SUBJECT: Campaign #95 –Rear Suspension Air Bag Upper Mount Reinforcement

**Instructions to Perform Campaign 95
2006 Winnebago View & Itasca Navion
(500-Series)
Air Bag Bracket Reinforcement**

Air Bag Bracket Reinforcement Kit-Part #RC7665-05-795

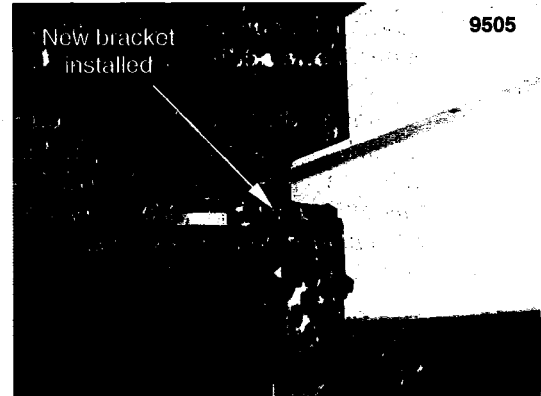
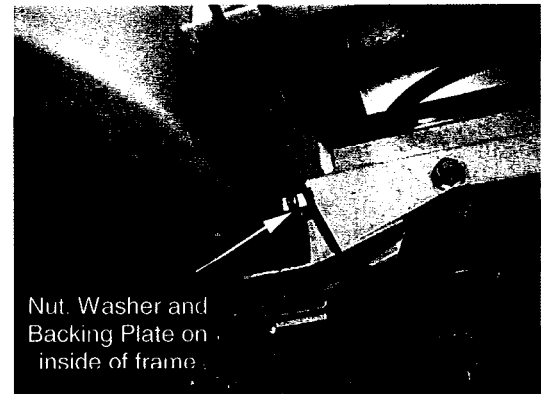
- 6) Install the new Air Bag Bracket 156281-02-02B and Backing Plate 156283-01-02B as shown in photo 9505 and 9506 at right and in Figure 1 and Figure 2 on page 4. The bolt will pass through an existing 1/2" hole in the frame rail.

- 8) Tighten the nut and bolt running through the frame rail (photo 9506) **until the new parts are snug, then tighten one additional turn only.**

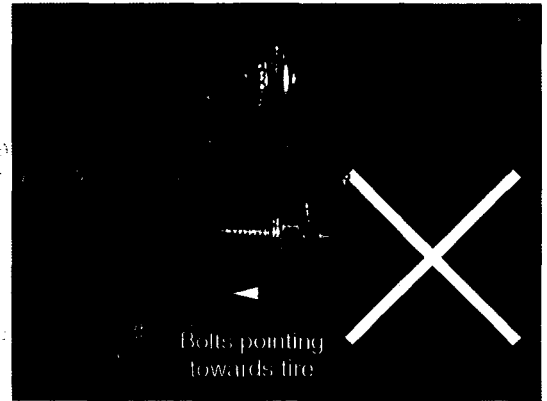
- 10) If the 5/16" X 3-3/4" lower attachment bolts are oriented with the nuts towards the tire (photo 9507), remove and replace them so they face away from the tire (photo 9508). Tighten until the metal bracket bends slightly and the nuts bottom out on the threads of the bolts.

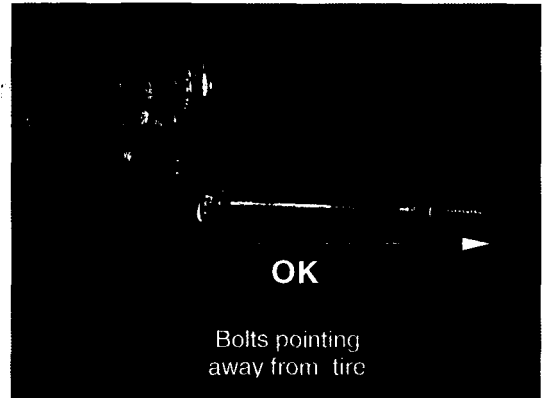
- 11) Inspect the upper air bag bracket. If the rivets (see arrows in photo 9509) are still holding the bracket tightly to the frame rail, the procedure is complete and you can skip step 12.

- 12) If the bracket is loose or the rivets have started to pull out of the rail, the rivets must be replaced with bolts as described in step 13. The wheels should be removed for this operation.

- 13) Drill rivets out with a 17/64" bit. Continue drilling through both sides of the frame rail and replace the rivets with Bolts 000C12-05-48B, Washer 000E13-14-00B, and Nuts 00D29-05-00B. The nuts and washers should be oriented to the inside of the chassis rail. Repeat for remaining rivets.
